**RE: Defect Information Report – Supplemental Report No. 3
11V-283, FL-607, Western Star Airlines
Dealer Notice**

Subject: Western Star Airlines

Models Affected: Specific Western Star 4900 vehicles with a standard cab height and a Detroit Diesel DD13 engine manufactured October 14, 2009, through September 19, 2011.

December 2011
FL607AB
NHTSA #11V-283
Transport Canada #11-196

Fig. 1, Disconnecting the Air Lines

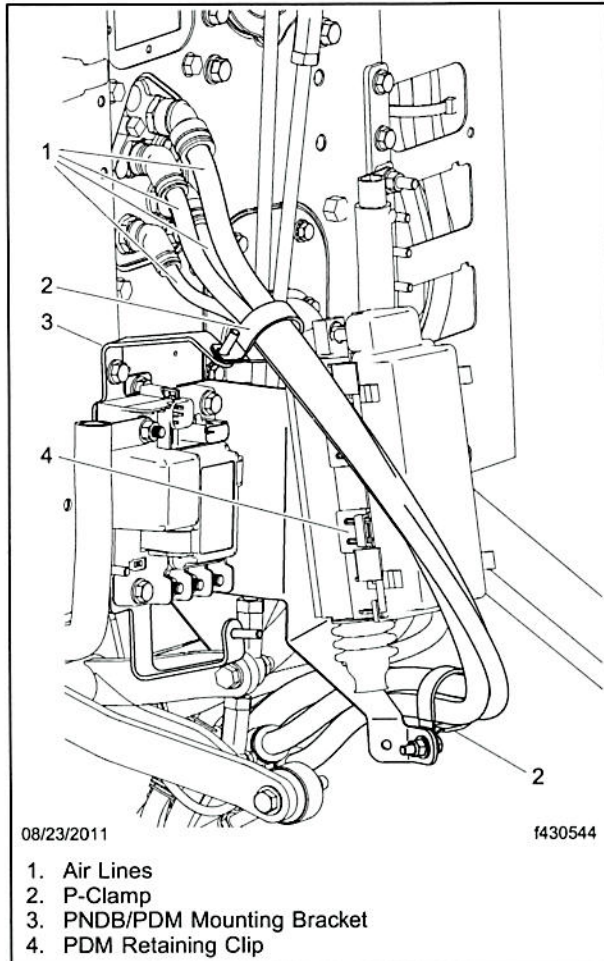
4. Open the hood.
5. Mark the air lines as needed, then disconnect them from the foot valve pass-through. See **Fig. 1**. Free the air lines from the PNDB/PDM mounting bracket, then push them out of the way to give access to PNDB/PDM mounting bracket.

6. Remove the power train PDM from the PNDB/PDM mounting bracket by releasing the two clips on the outboard side of the PDM. See **Fig. 1**.
7. Mark all of the electrical cables and their positions on the PNDB, then disconnect them from the PNDB. See **Fig. 2**.

Fig. 2, Electrical Connections, PNDB

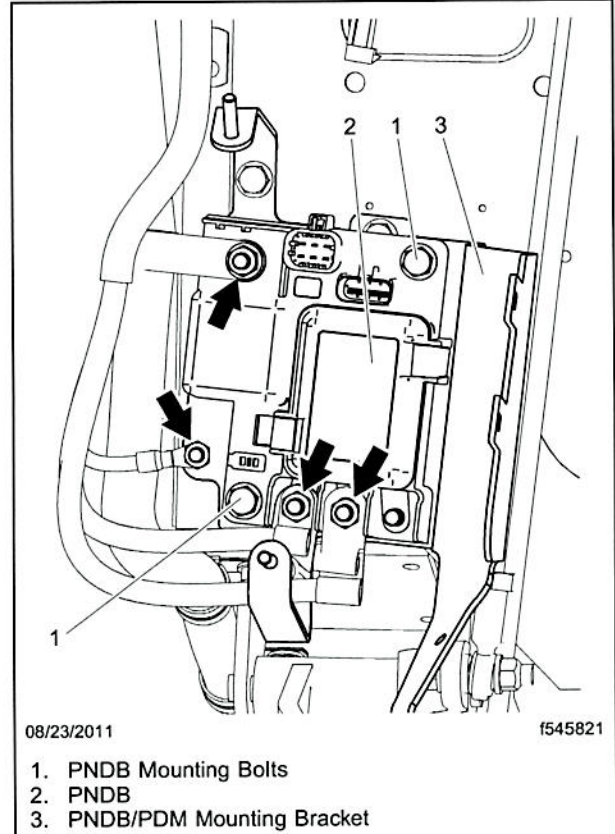
8. Remove the PNDB from the PNDB/PDM mounting bracket. See **Fig. 2**.
9. Remove the PNDB/PDM mounting bracket from the front wall. See **Fig. 2**.
10. Install the new PNDB/PDM mounting bracket from the kit on the front wall.

Fig. 3, Replacing Cables

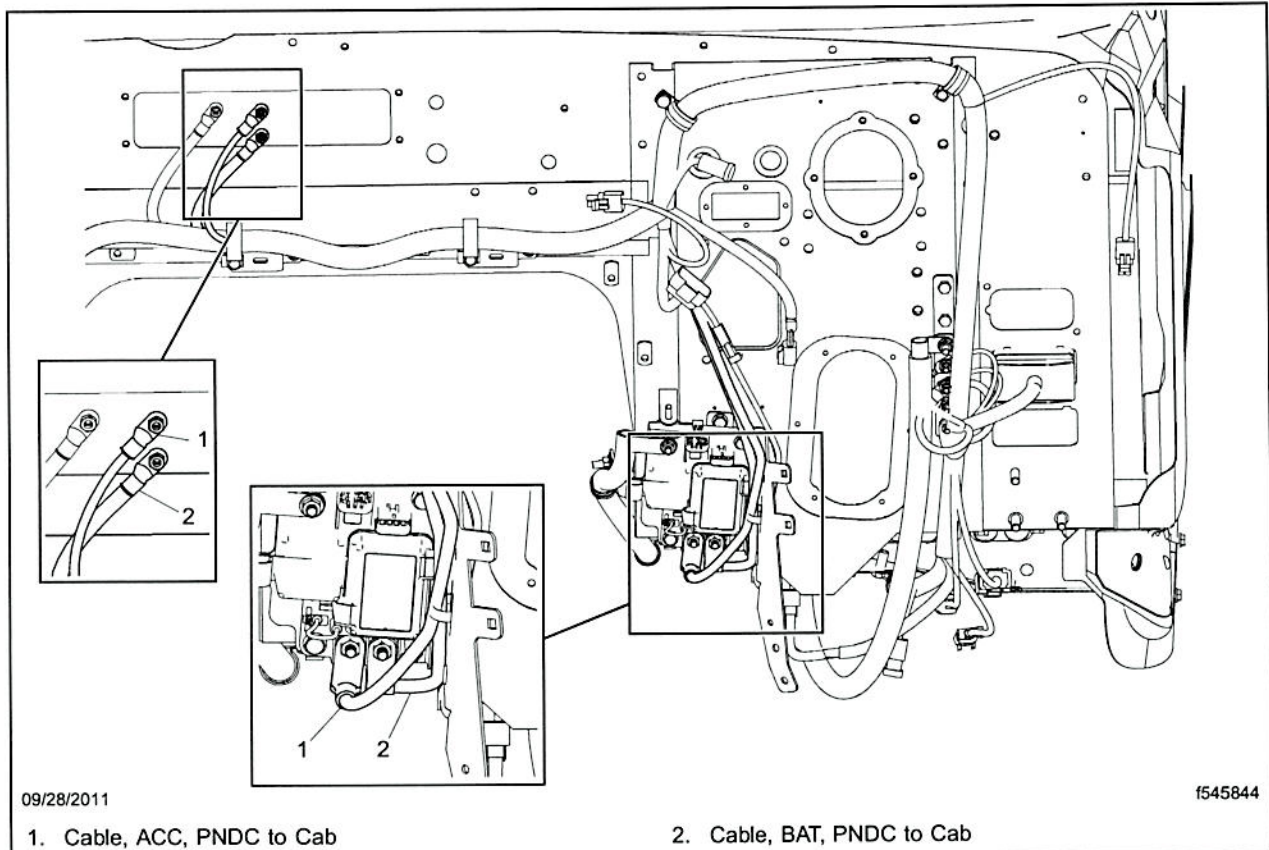
11. Remove the cover in the center of the front wall above the engine, and remove the convoluted tubing from the wiring harness.
12. Disconnect and remove the two cables that go from under the cover to the PNDB from the wiring harness. See **Fig. 3**.

13. Install the two new cables from the kit to the front wall and install the cover.
14. Run the new cables with the wiring harness and install the convoluted tubing on the harness.

Fig. 4, New Electrical Connections, PNDB

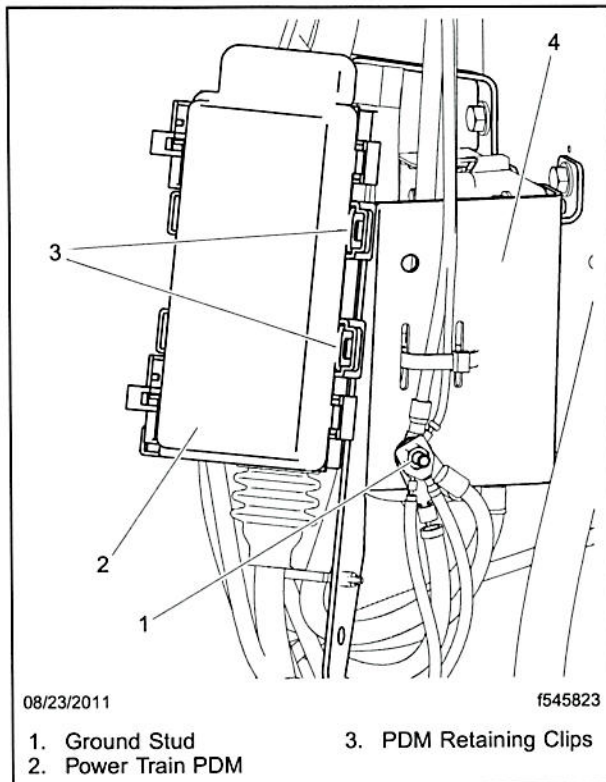
16. Connect all of the electrical connectors and cables to the PNDB. See Fig. 4.

18. Install the power train PDM on the PNDB/PDM mounting bracket. See Fig. 4.

Fig. 5, Air Line Installation, New Bracket

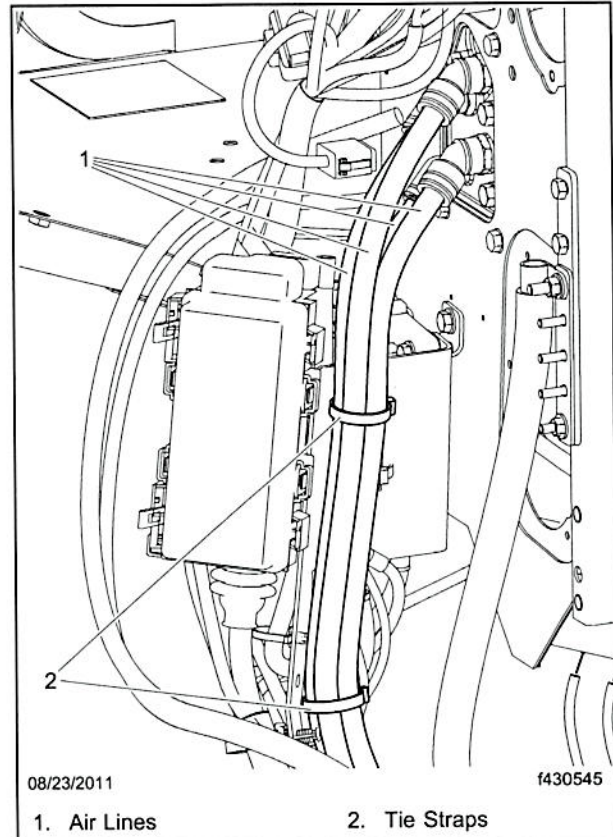
NOTE: It may be necessary to shorten the air lines to get them to fit in the new configuration.

17. Secure the air lines to the PNDB/PDM mounting bracket, then connect them to the foot valve pass-through. See Fig. 5.
